**TOWN OF NEWBURGH  
PLANNING BOARD  
TECHNICAL REVIEW COMMENTS**

**PROJECT NAME: LZL EQUITIES INC. (DUNKIN DONUTS)**  
**PROJECT NO.: 14-02**  
**PROJECT LOCATION: SECTION 14, BLOCK. 1, LOT 43**  
**REVIEW DATE: 25 SEPTEMBER 2015**  
**MEETING DATE: 1 OCTOBER 2015**  
**REPRESENTATIVE: MERCURIO NORTON TAROLLI MARSHALL**

**Site Plan  
for  
LZL Equities, LLC**

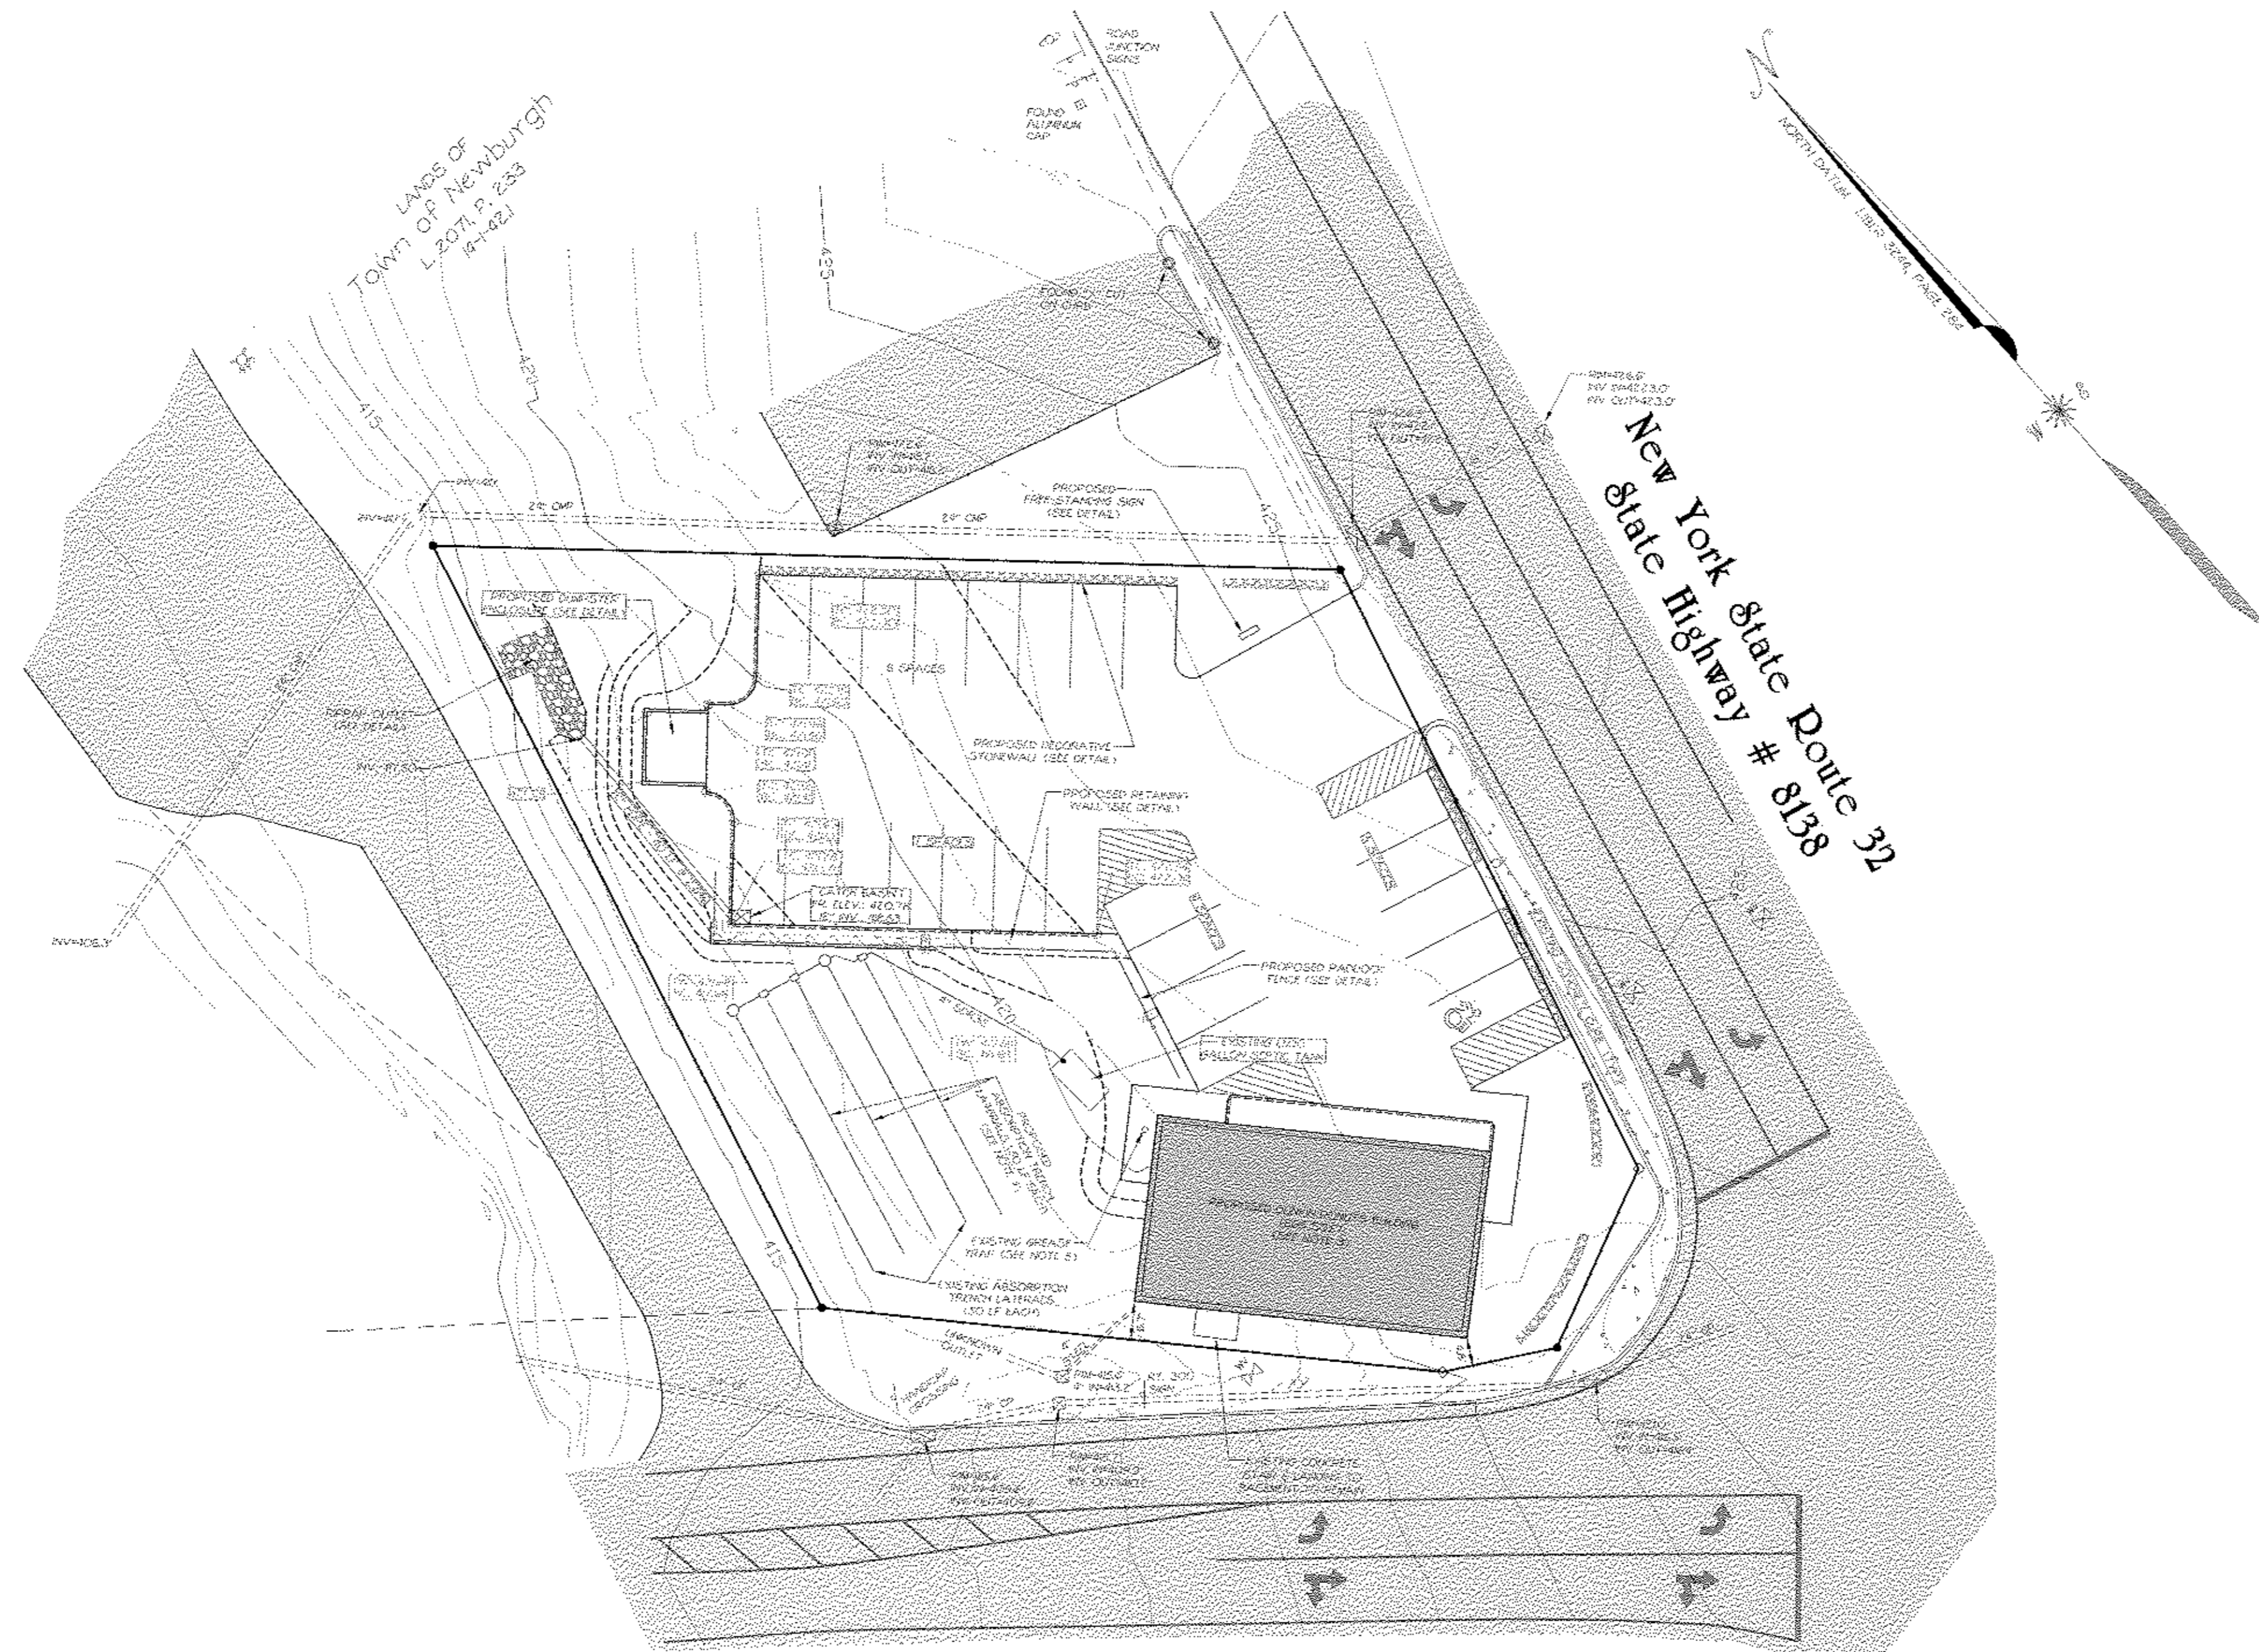
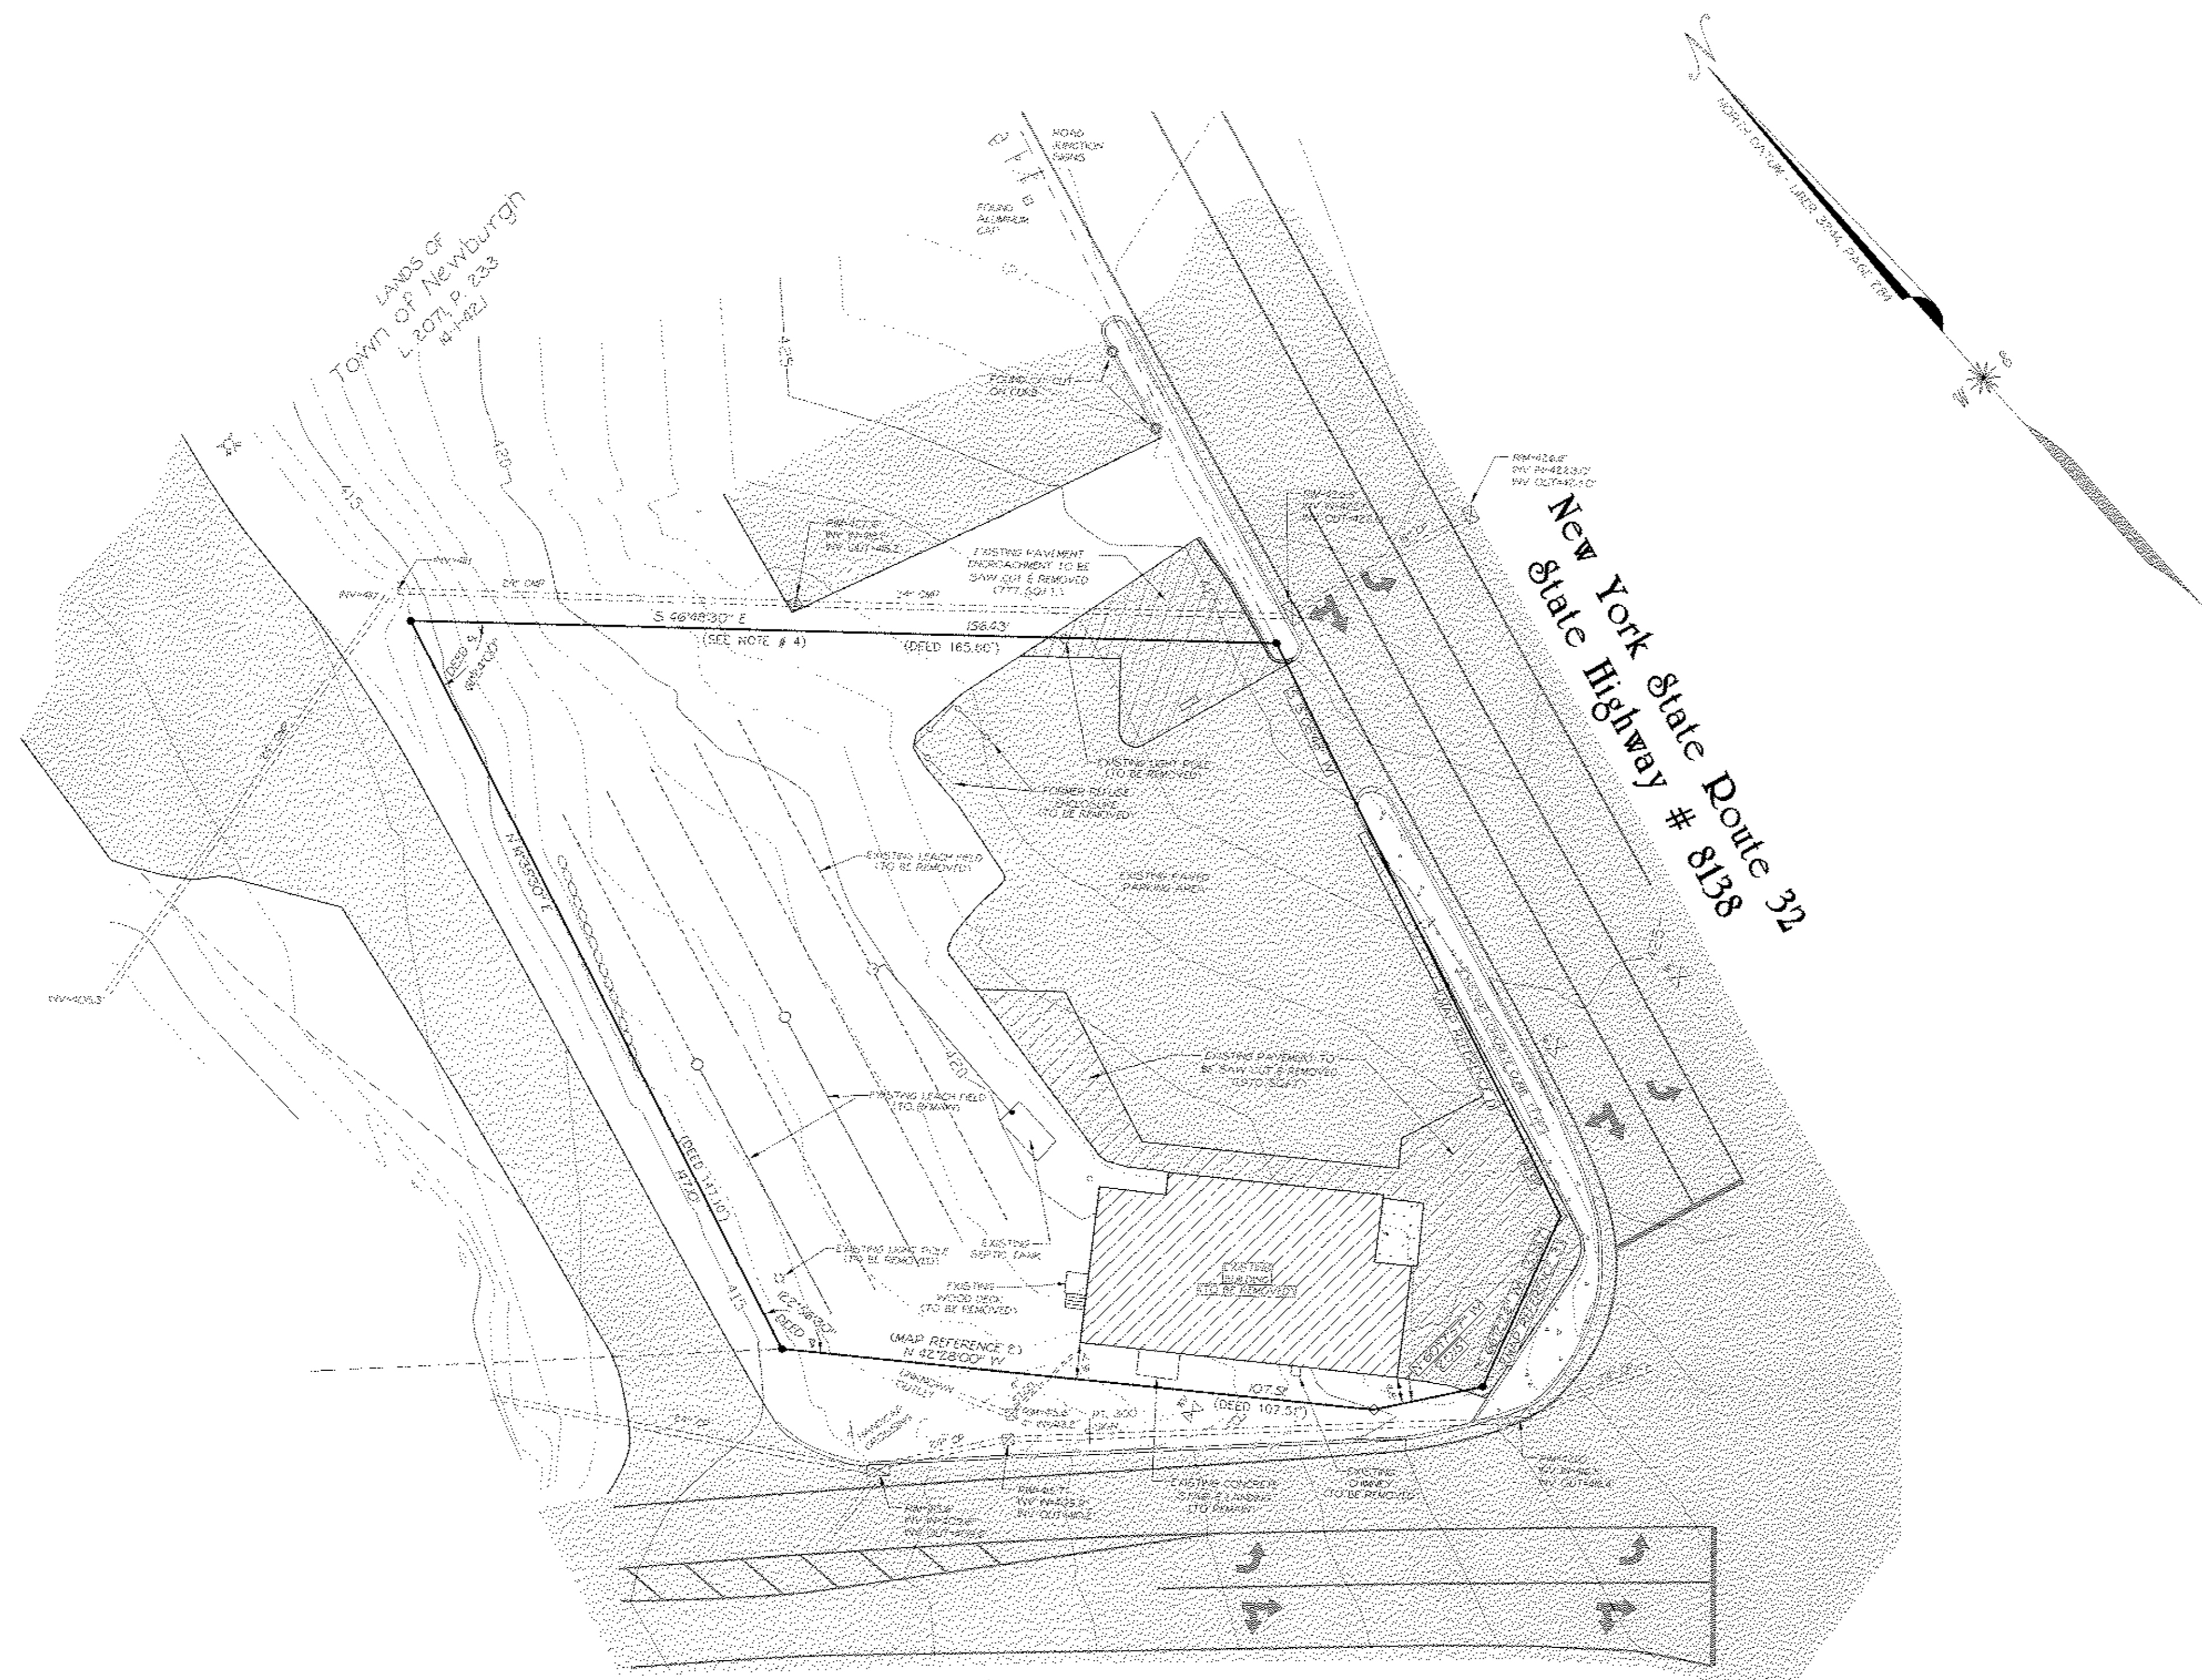
1. Site plan has been revised to provide additional parking for the Dunkin Donut facility.
2. Design flow calculations supporting the 400 gallon per day leach field design should be submitted. Information pertaining to the application rate of .8 gallons per day should also be provided. If this is from original plan, provide reference to original design plans.

5. NYSDOT's comments regarding the driveway access should be received along with Ken Wersted's review of internal traffic circulation.
6. Curbing is proposed around a section of the new parking lot to control drainage which will discharge via a small section of pipe to the existing swale to the west of the property.

7. Erosion and sediment control details and the location of erosion control practices should be added to one of the plan sheets.
8. Revised landscape plan has been provided for the Planning Board's review. Planning Board's input on the plan should be received. It is noted that the dry laid stone walls continue to be proposed on the site to address parking in the front yard setback which is not in compliance with design guidelines.

9. Delivery truck access to the site may be difficult during busy times. The Applicant's Representative should discuss methods of material delivery and possibly restrictions on time in which vehicles can access the site.
10. Note 3, the word raised should be revised to read razed. No change in elevation is proposed.
